OUR TOWN HALL PROJECT

PROJECT STATUS	RIBA STAGE 5
CLIENT	MANCHESTER CITY COUNCIL
PROJECT	OUR TOWN HALL
DRAWING TITLE	Rooflight WCR01 Existing and Proposed - plans
SIZE & SCALE	A1: Scale as Stated
DRAWING STATUS	ISSUED FOR CONSTRUCTION
JOB NUMBER	236959
DRAWING NO.	OTH-PUR-TH-RF-DWG-A- 7480
REV	02

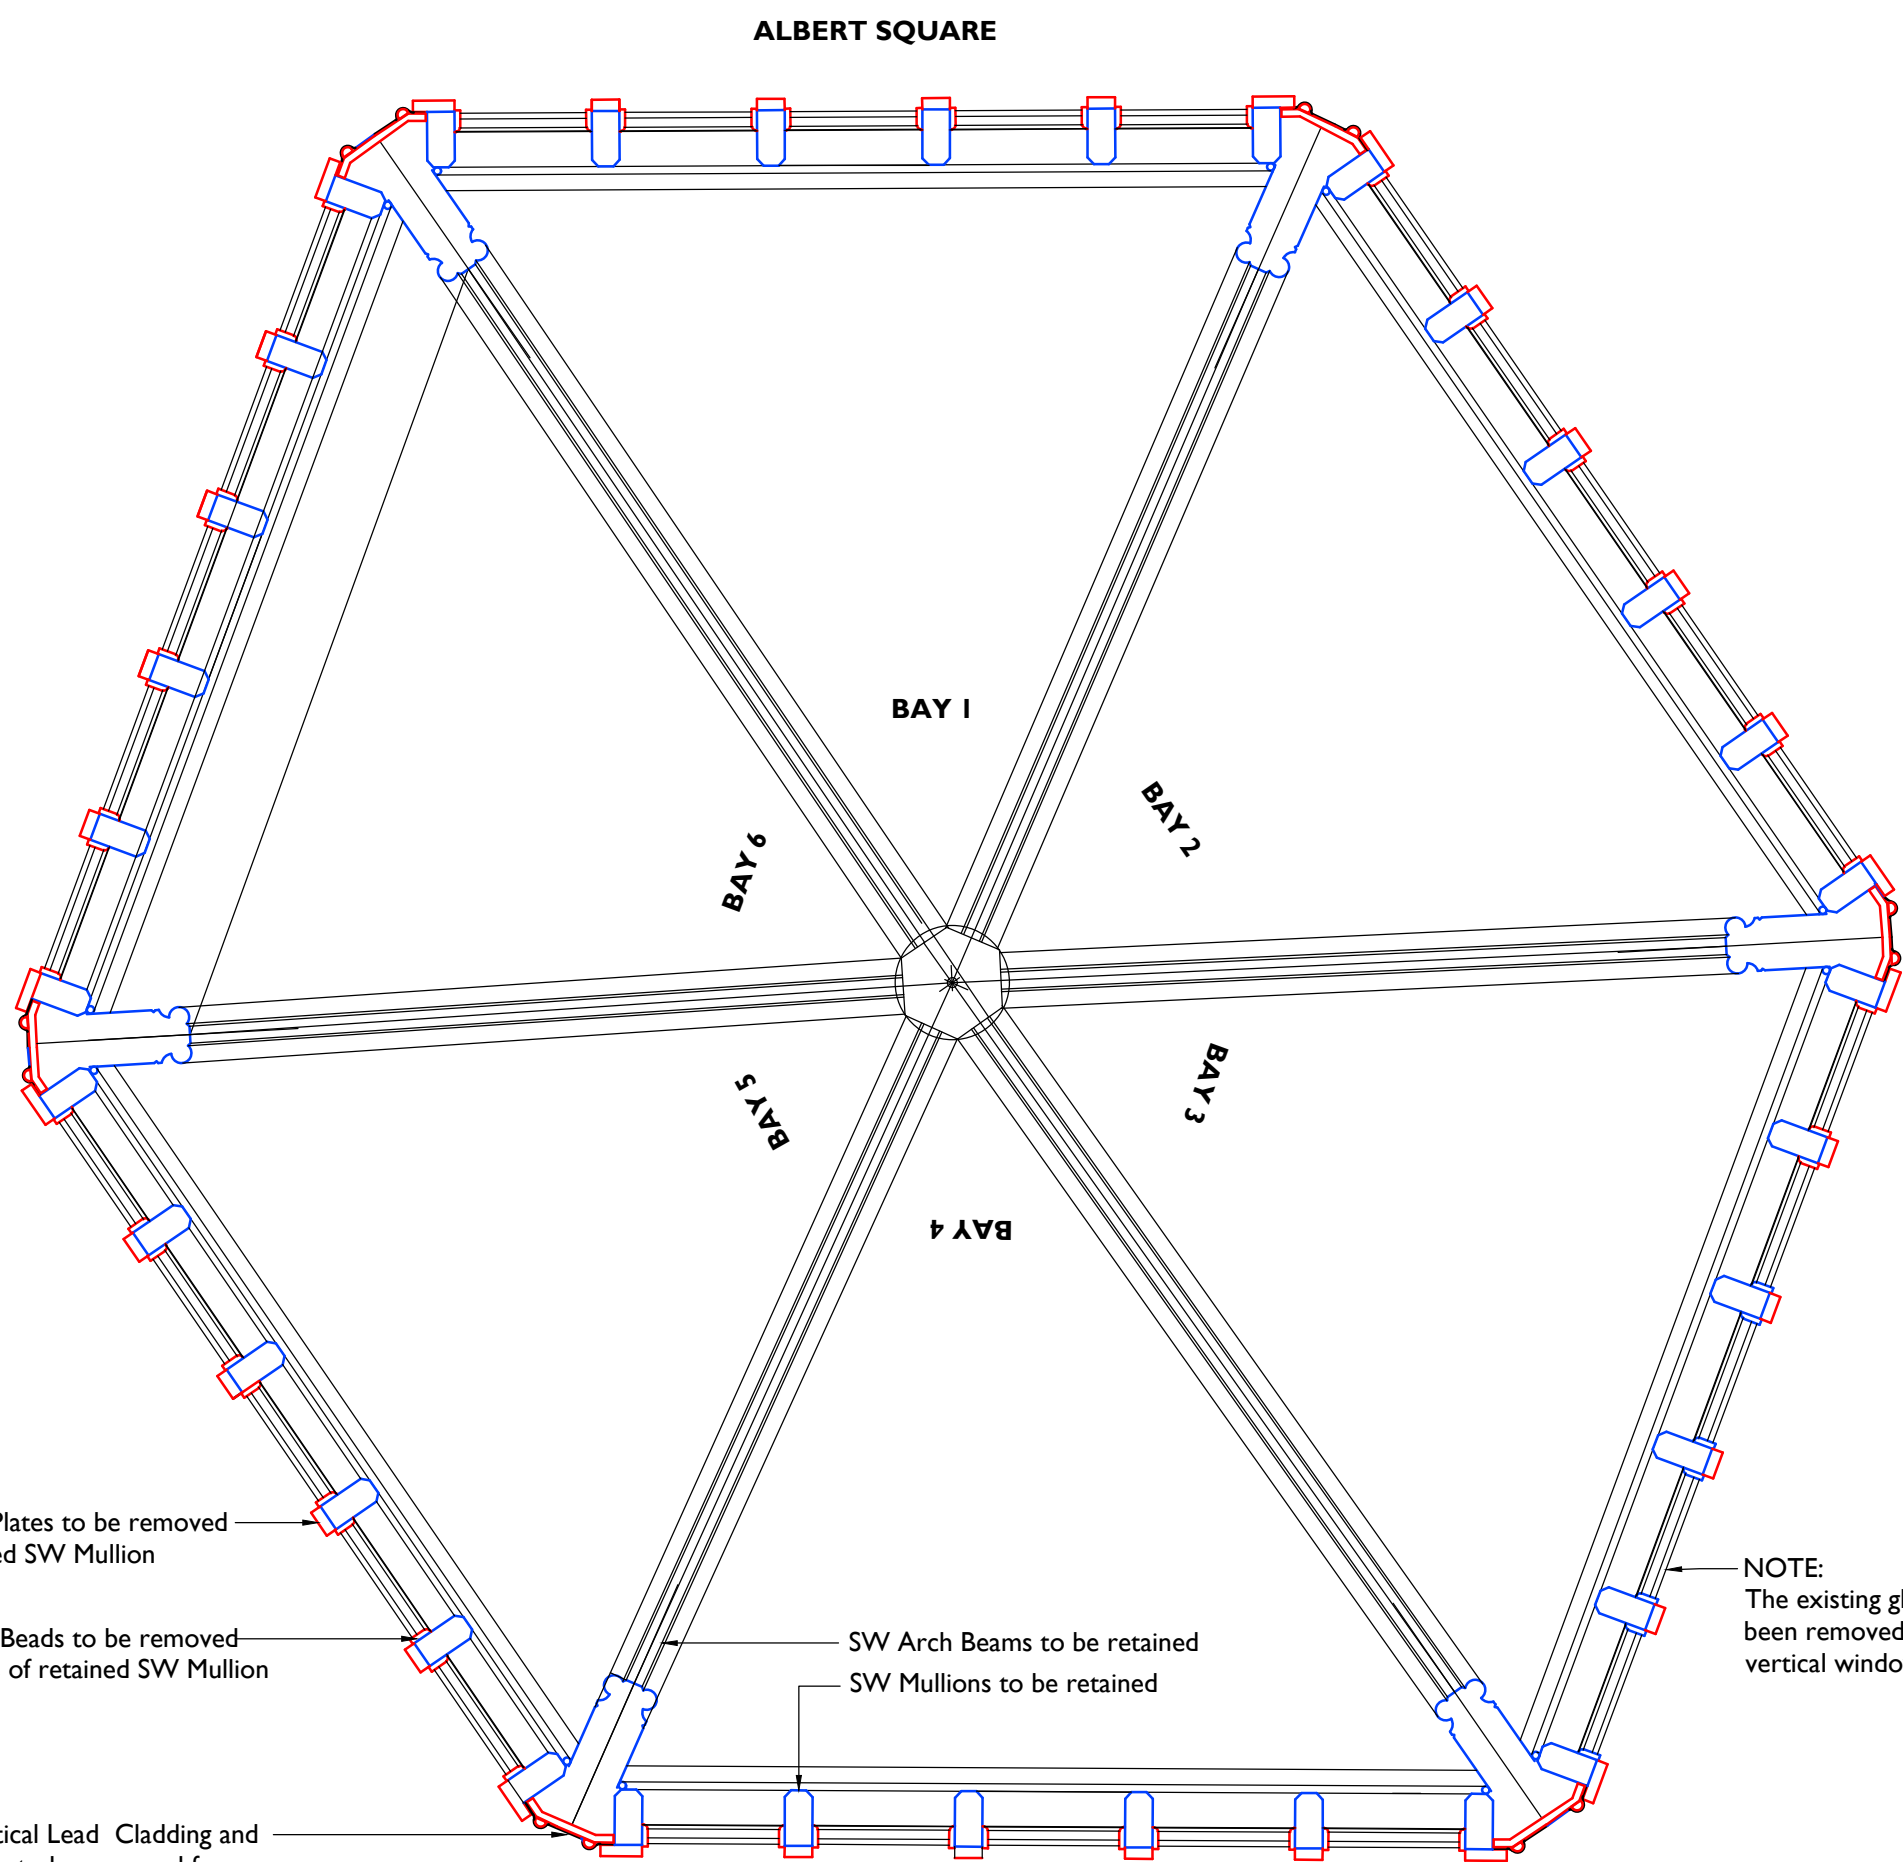
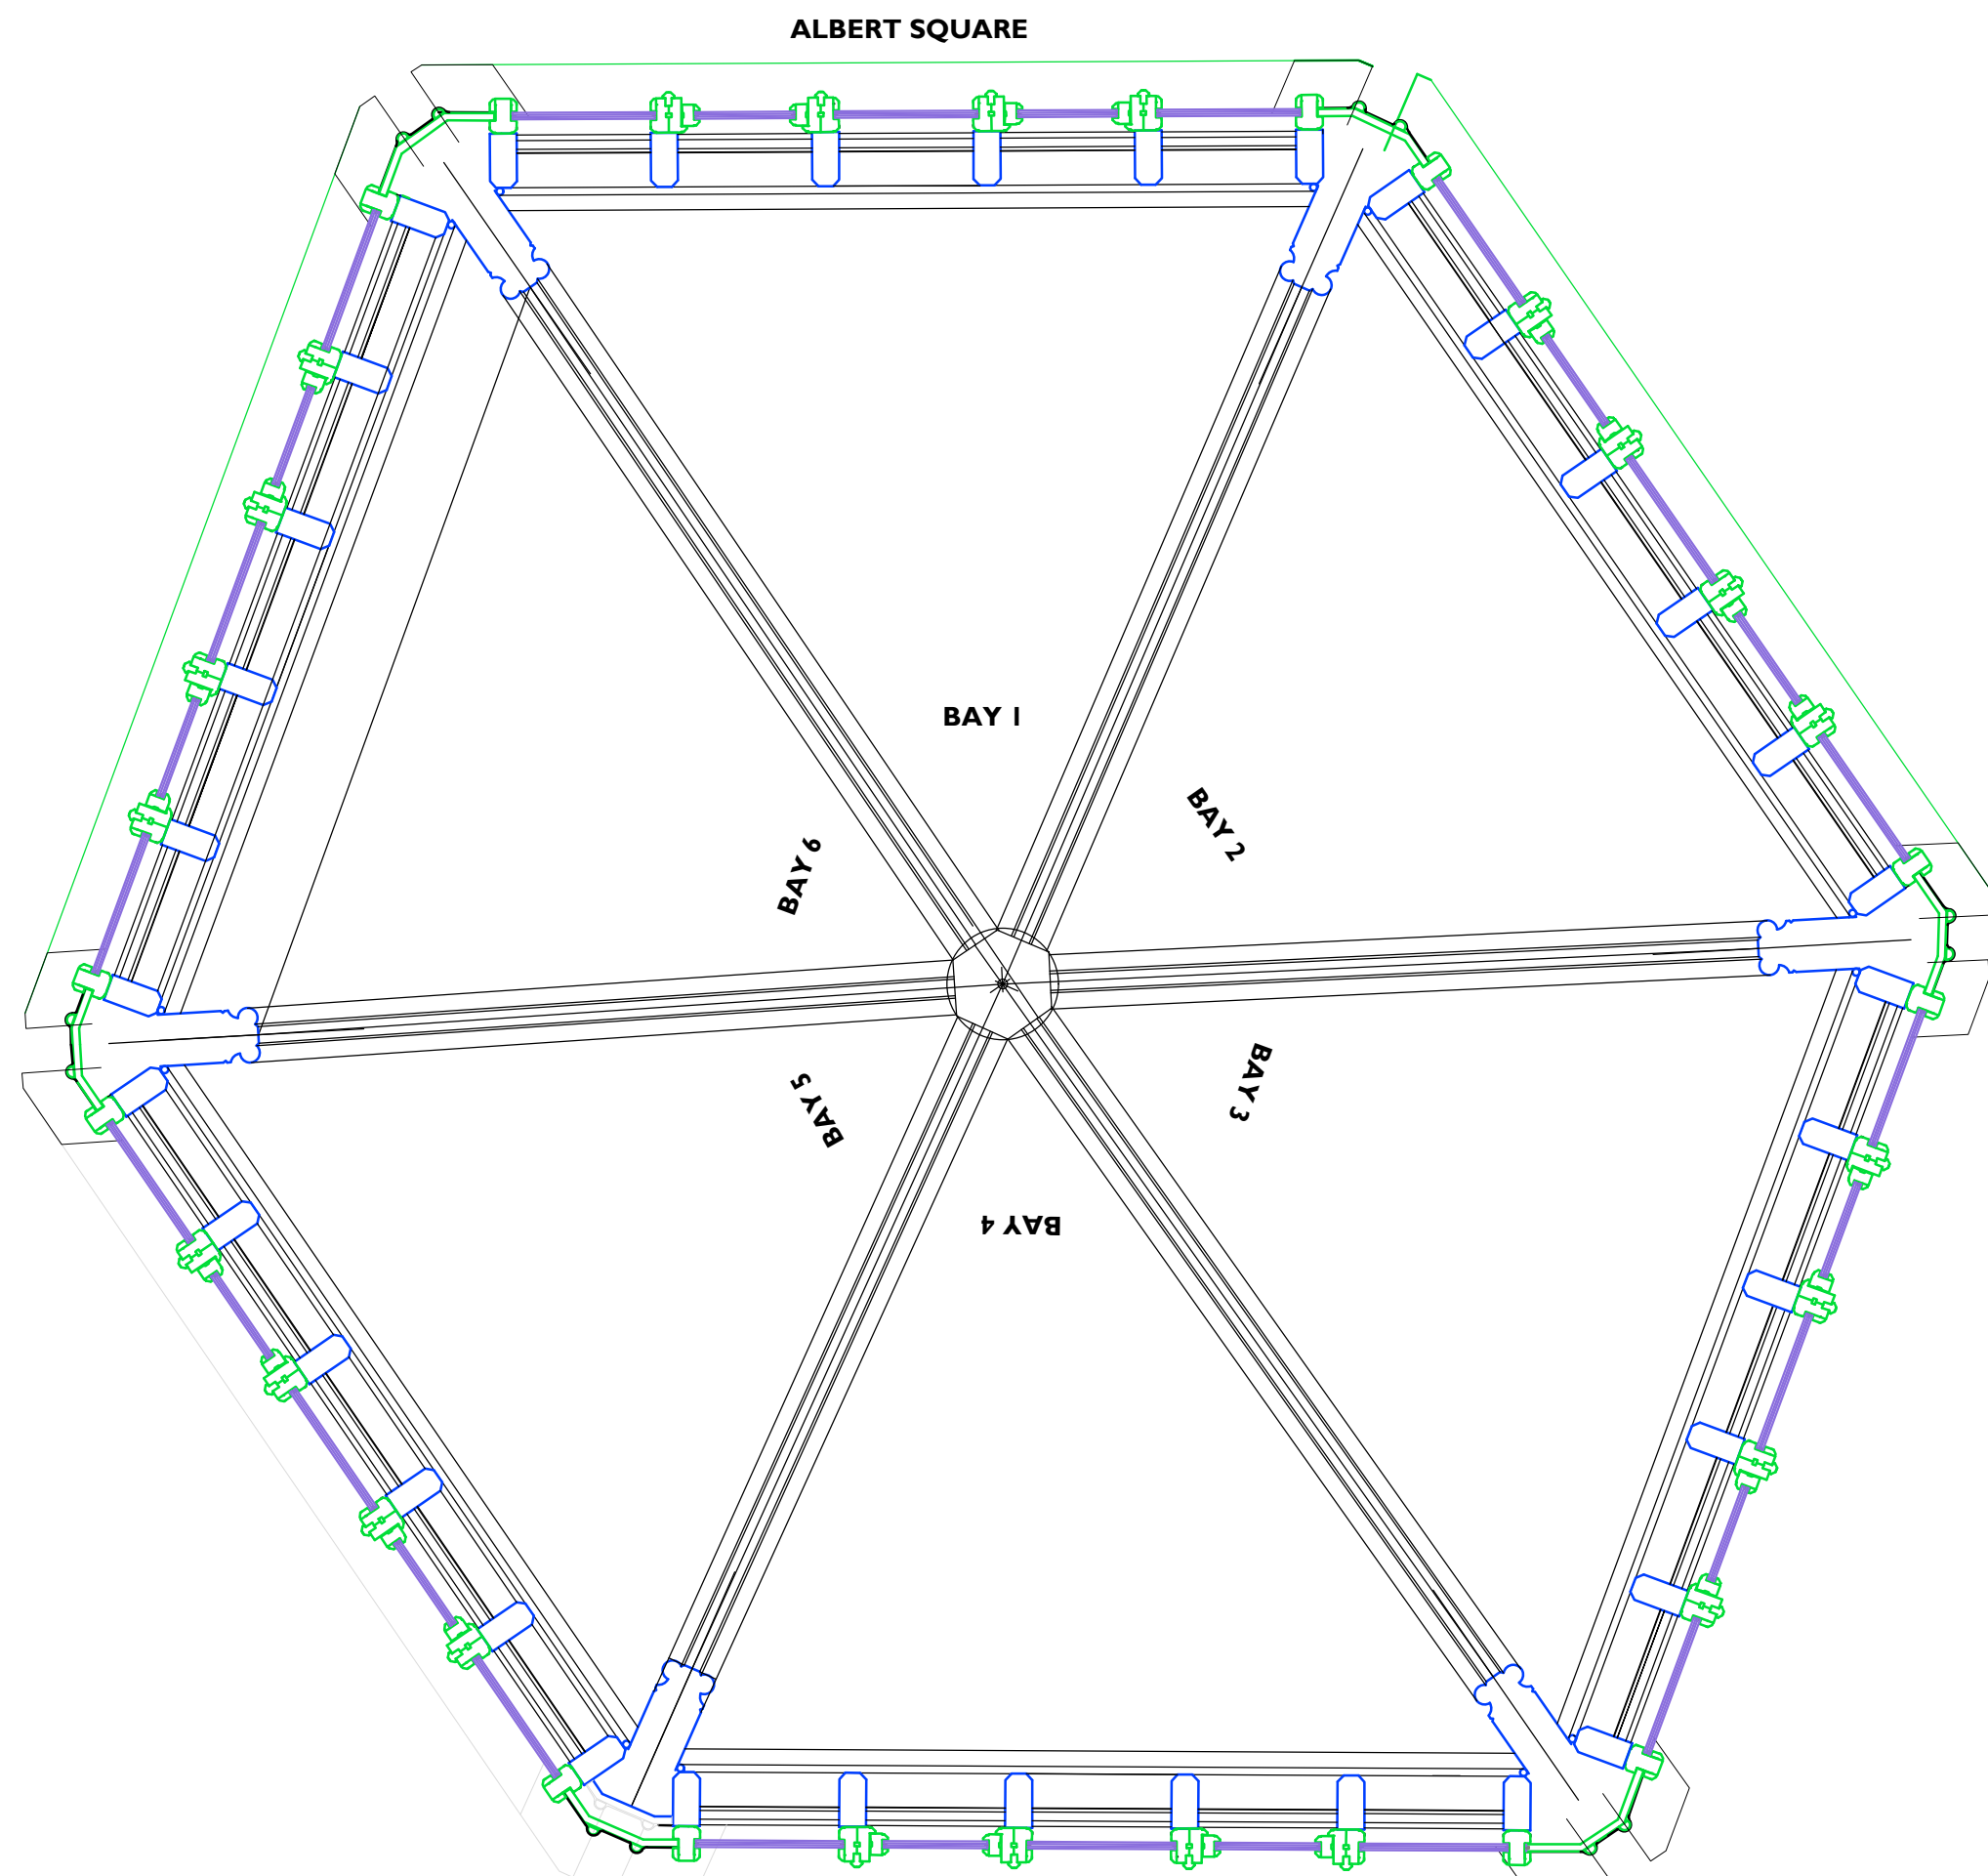
Rev 02	12/11/2023	JC	SE	Set-out of glazing bars and lead hip guttering amended slightly
Rev 01	04/10/2023	JC	SE	PPC Verge Flashings changed to lead. Timber Glazing Bars increased in depth and changed from Oak to C24 Douglas Fir. Retention clips added to lower edge of glazing
29/08/2023	SE	SE	First Issue	
ISSUE	DATE	APPROVED	DRAWN	DESCRIPTION
